ADDENDUM #4

Re: INVITATION FOR BIDS: **16-051-NT, Gilead-Bloomfield Complex Renovation**

### Addendum No. 4 Question Responses

1 **MILLWORK DETAIL**  
 SD-2 1-1/2"=1'-0"  
 REVISION TO 14/A501

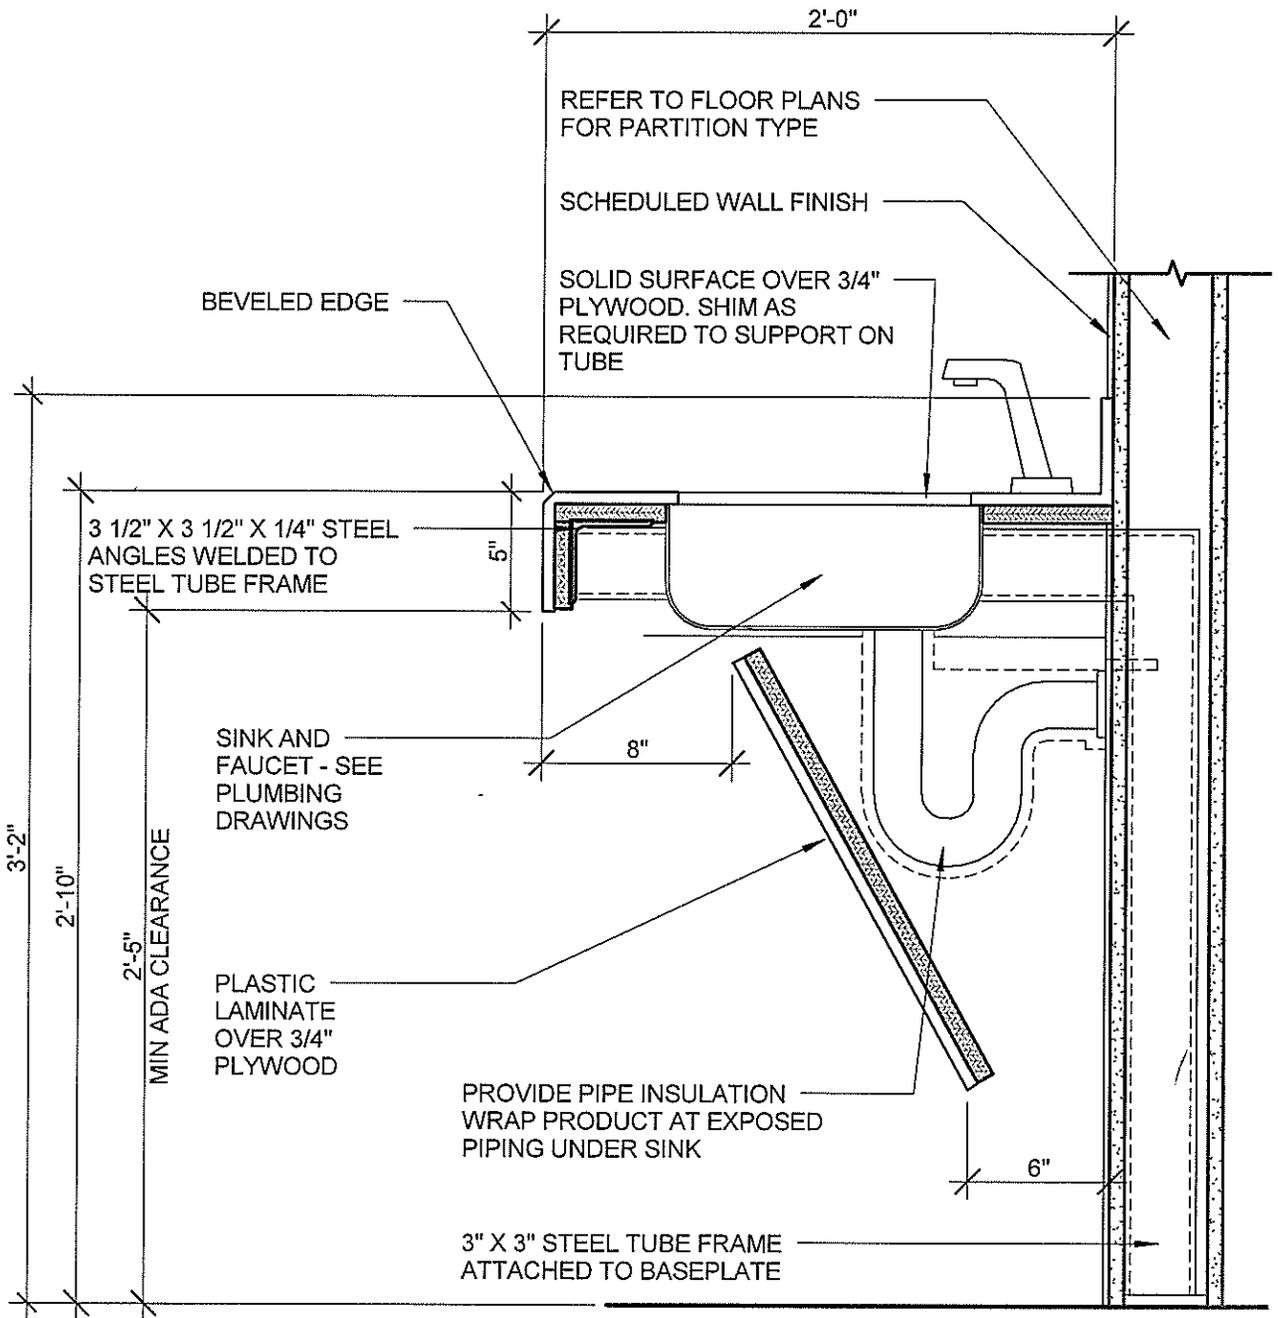
2. Q: Detail 14/A501 calls for plastic laminate vanity top and also an undermount sink. Is this correct?

14. Q: Please advise what material the new lavatory counter tops should be made of. The section on the drawings indicate plastic laminate on 3/4" substrate. The specification section 06 6116 Solid Surfacing Fabrications indicates lavatory tops, window sills and integral sinks and bowls are to be solid surface material. Plumbing fixture indicates an under mount sink.

A: Lavatory LV-2 is to be undercounter mounted. The countertops are to be solid surface material SS-1 – Corian Abalone or equal per the attached supplemental drawing SD-2 to replace 14/A501.

A: Lavatory LV-2 is to be undercounter mounted. The countertops are to be solid surface material SS-1 – Corian Abalone or equal per the attached supplemental drawing SD-2 to replace 14/A501.

1  
SD-3

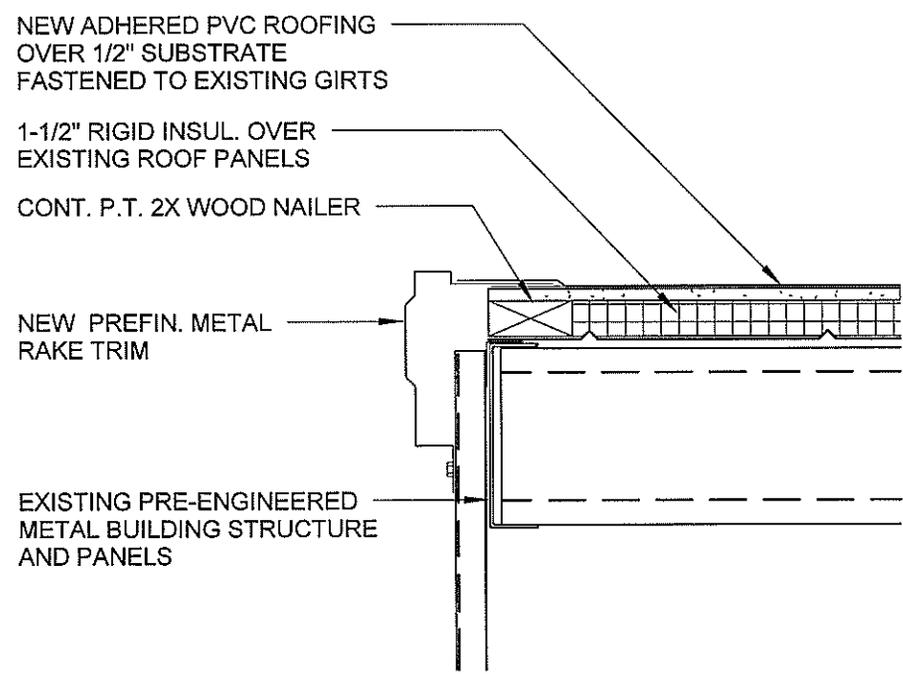
12. Q: Please show a wood blocking detail for the eaves and rakes on the metal building PVC retrofit roofing areas.

A: See attached supplemental drawing SD-3. The eave and rake profile are to be similar to the existing components.

1  
SD-4  
DETAIL AT FLASHING  
1-1/2"=1'-0"

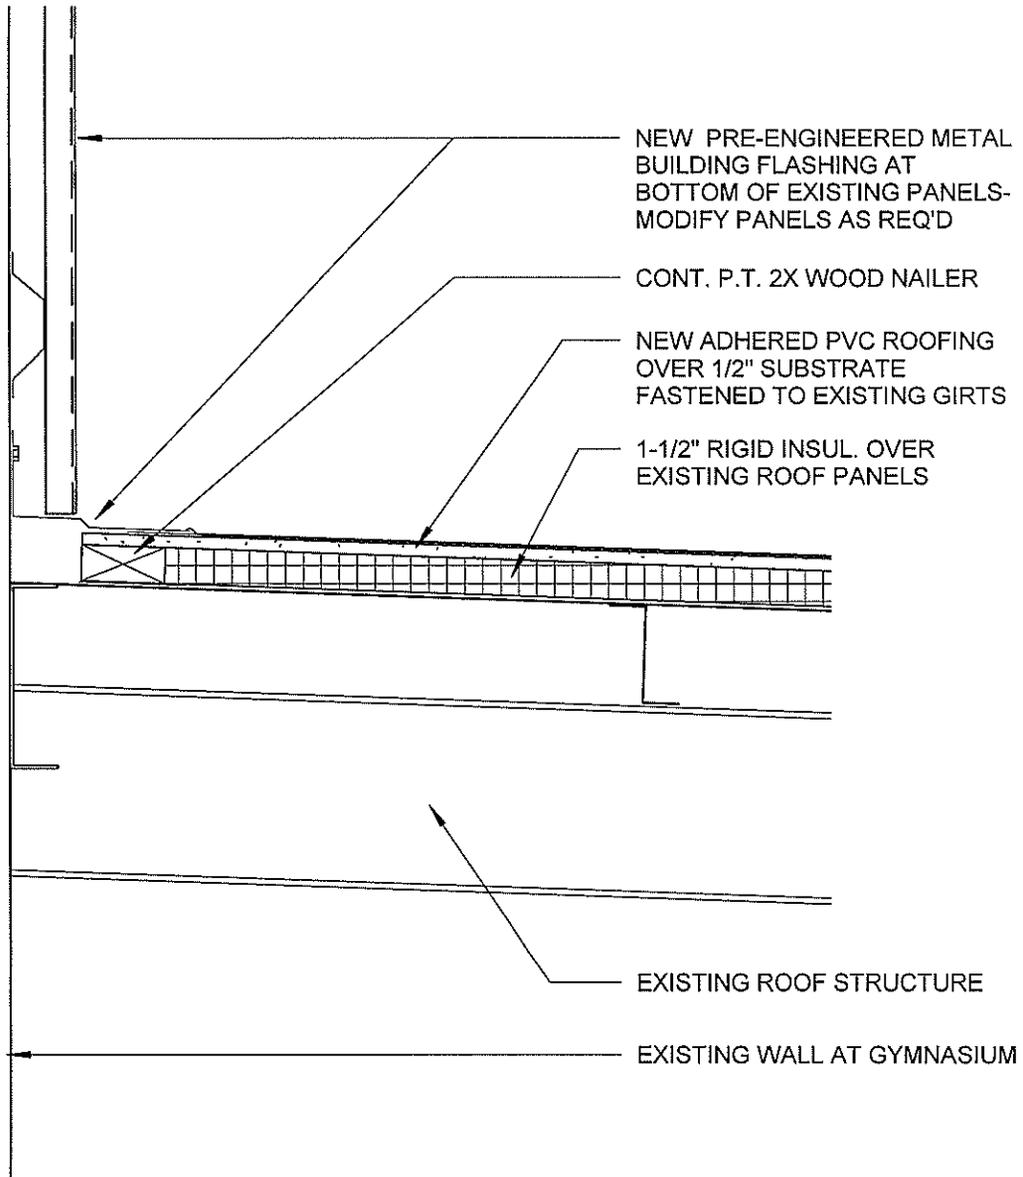
13. Q: Please show a detail of the flashing condition at the roof to wall areas on the metal buildings. (Low roof to high roof).

A: See attached supplemental drawing SD-4.
